Sundry Print Report

Well Name: BROWN 93	Well Location: T9S / R37E / SEC 24 / NENW / 33.5251912 / -103.1081939	County or Parish/State: LEA / NM
Well Number: 01	Type of Well: OIL WELL	Allottee or Tribe Name:
Lease Number: NMNM0103893A	Unit or CA Name:	Unit or CA Number:
US Well Number: 3002523975	Operator: DUGAN PRODUCTION CORPORATION

Notice of Intent**Sundry ID:** 2788403**Type of Submission:** Notice of Intent**Type of Action:** Plug and Abandonment**Date Sundry Submitted:** 05/04/2024**Time Sundry Submitted:** 12:15**Date proposed operation will begin:** 05/11/2024**Procedure Description:** See attached documents**Surface Disturbance****Is any additional surface disturbance proposed?:** No**Oral Submission****Oral Notification Date:** May 4, 2024**Oral Notification Time:** 12:00 AM**Contacted By:** Zota Stevens**Contact's Email:** Zstevens@blm.gov**NOI Attachments****Procedure Description**

**BLM Revised Plug and Abandonment
Procedure**

Proposed Wellbore Diagram

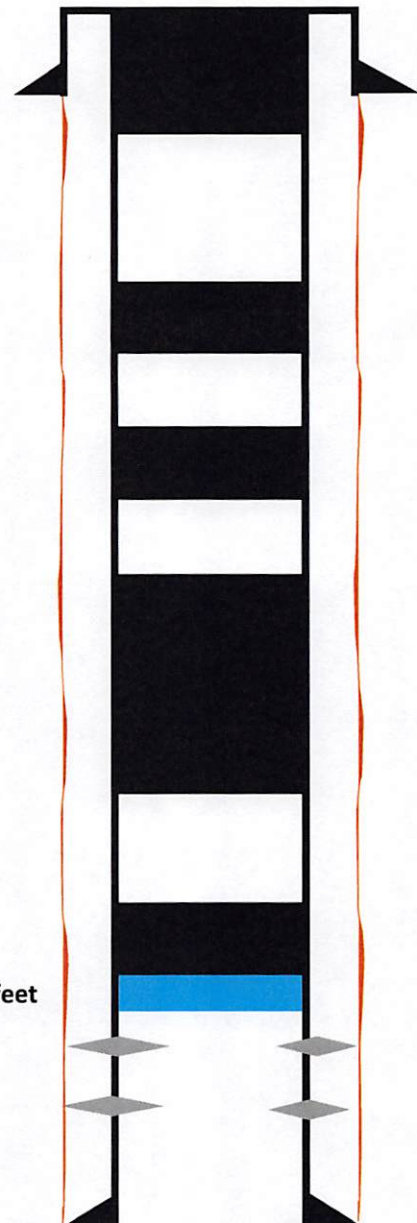
7. RU wireline and run CBL with 500 psi on casing from CR at 4,870' to surface to identify TOC. Adjust plugs as necessary for new TOC. **Contact BLM at 575.361.8620.** Email log copy to Brandon Powell at Brandon.powell@state.nm.us upon completions of logging operations.

Mix 25 sx Type I/II cement and spot a balanced plug inside casing to cover the perforations and Pi formation top. **WOC and TAG**

Mix 25 sx Type I/II cement and spot a balanced plug inside casing to cover the Yates and Salt formation tops. **WOC and TAG**
